# DEVELOPMENT HEARING OFFICER

**PR-2024-009917**

SD-2024-00092

**REQUEST:** REPLAT OF 2 EXISTING LOTS

# DEVELOPMENT SKETCHES ATRISCO BUSINESS PARK

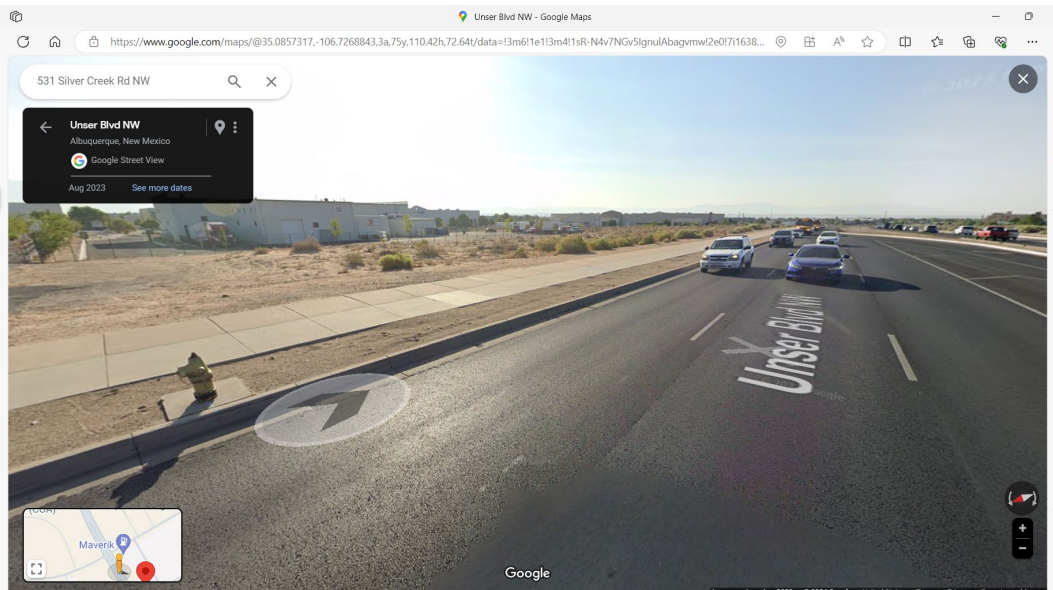
- Please note that per the Atrisco Business Park Master Development Plan, properties adjacent to Unser Boulevard shall have a 6-foot wide sidewalk with a minimum 12-feet between the back of curb and the sidewalk. An analysis of the site in Google Street View (see picture below) appears to depict a sidewalk at least 6-feet in width, but the landscape buffer doesn't appear to be a minimum of 12-feet in width between the back of curb and the sidewalk as required by the Atrisco Business Park Master Development Plan.

Properties adjacent to Unser Boulevard shall have a 6 foot wide sidewalk with a minimum landscaped area of 12 feet between the back of curb and the sidewalk. All other collector and major local streets within the site shall have 4 foot wide sidewalks. It is recommended that the sidewalk

**Update – 6/10/23:** The Applicant has submitted a sidewalk/buffer exhibit confirming a 12-foot-wide concrete trail and a 6-foot-wide landscape buffer between the back of curb along Unser and the sidewalk. Per 2-5(B)(3)(g)(2) of the IDO, a Variance from Master Development Standards may be granted pursuant to the same thresholds and procedures as established by 6-6(P) of the IDO, which permits the DHO to approve a Determination from the landscape buffer requirement provided the justification criteria per 6-6(P)(3) of the IDO are determined to be met. Therefore, a DHO Determination letter for the landscape buffer along Unser must be submitted.
